Technical Memorandum

To	North Kent 1 LP	Page	1
CC	Mark Van der Woerd (AECOM), Jody Law, Joshua Vaidhyan		
Subject	North Kent Wind 1 (Chatham-Kent, ON) Well Water Impact Complaint Investigation – UPDATED v.2 [REDACTED] - PIN 007460069, [REDACTED]		
From	Jason Murchison, P.Geo.		
Date	November 15 th , 2017	Project No.	60343599

**WATER WELL COMPLAINT 1
NORTH KENT WIND 1 PROJECT
CHATHAM-KENT, ONTARIO**

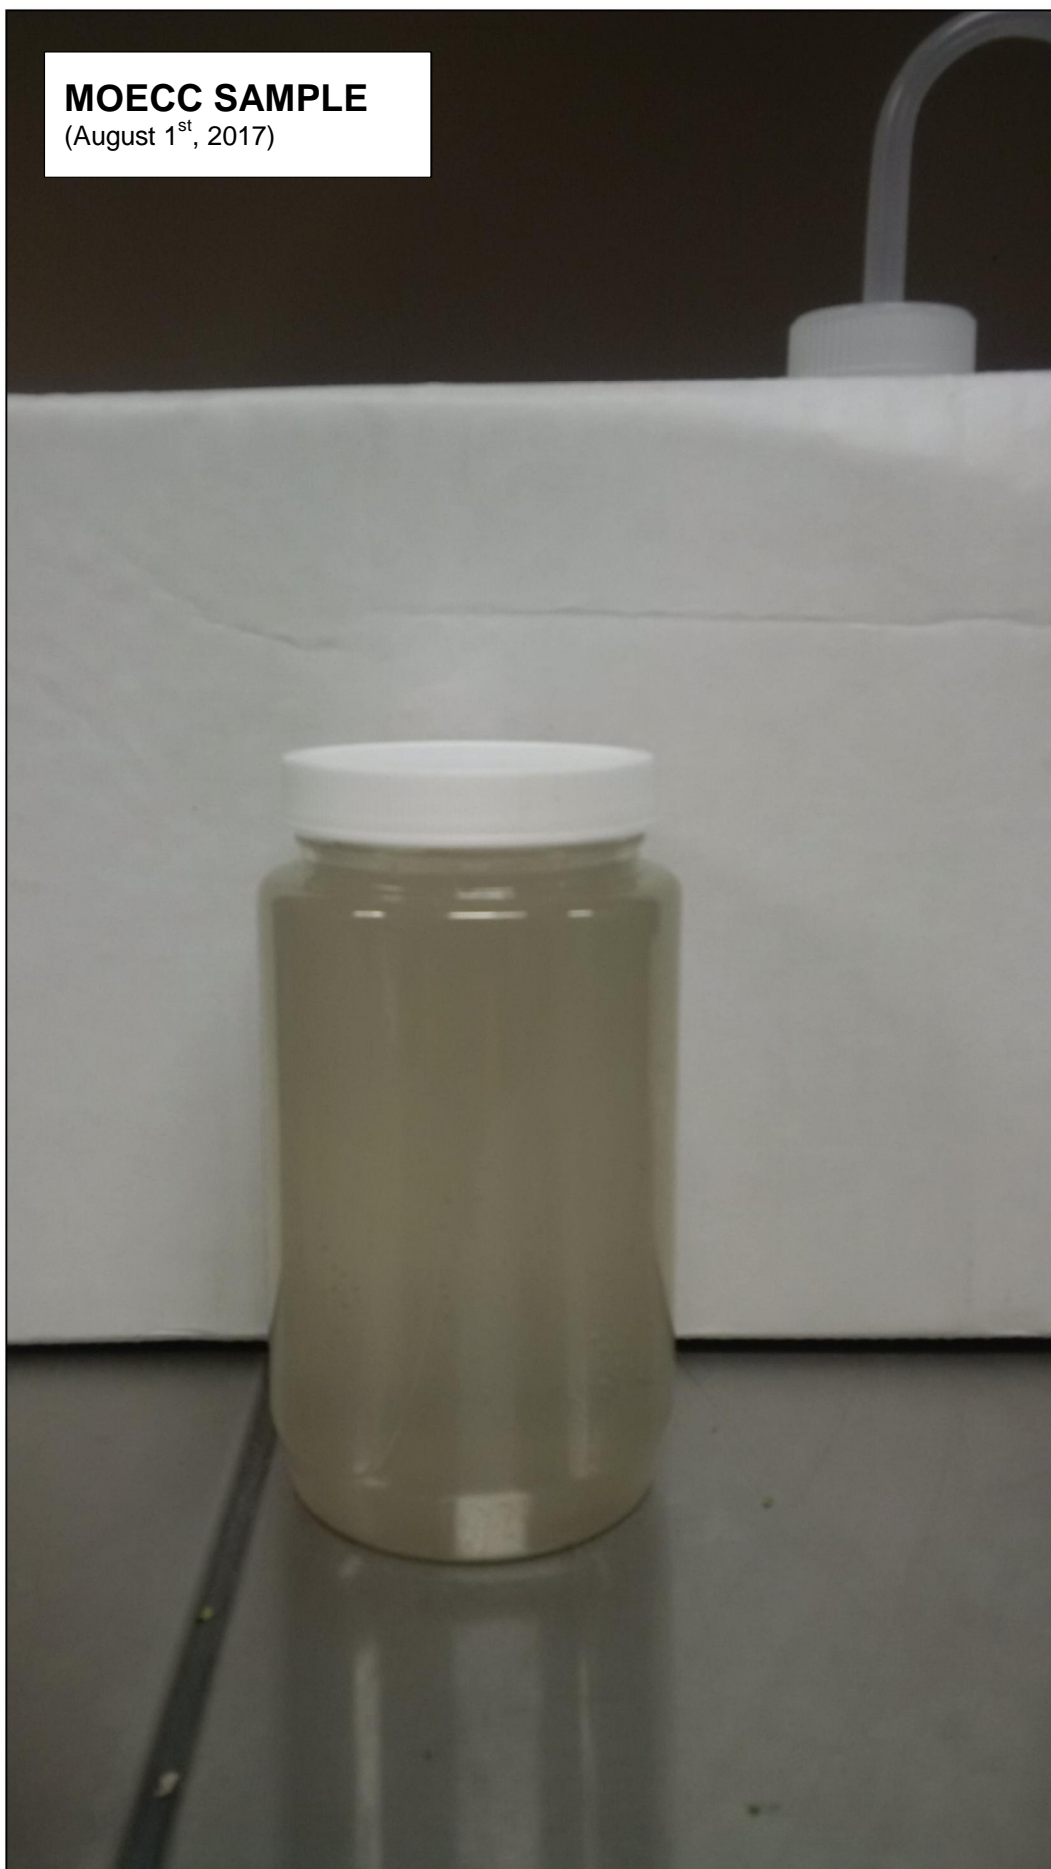
I have also seen a photo provided by [REDACTED] via email to Jody Law the evening of Aug. 3. It purports to be a photo of the sample taken by AECOM during their Aug. 2 visit to the [REDACTED] residence. In that photo, the sampled water appears noticeably cloudy (see attached)

I am trying to reconcile this varying information. Is AECOM saying that the cloudy water collected and photographed during the Aug 2, 2017 visit is visually the same as the 6.2 NTU samples taken Feb. 2, 2017? Are there any photos of the Feb 2 sample? I am hoping that Aecom's report will address / answer these questions.
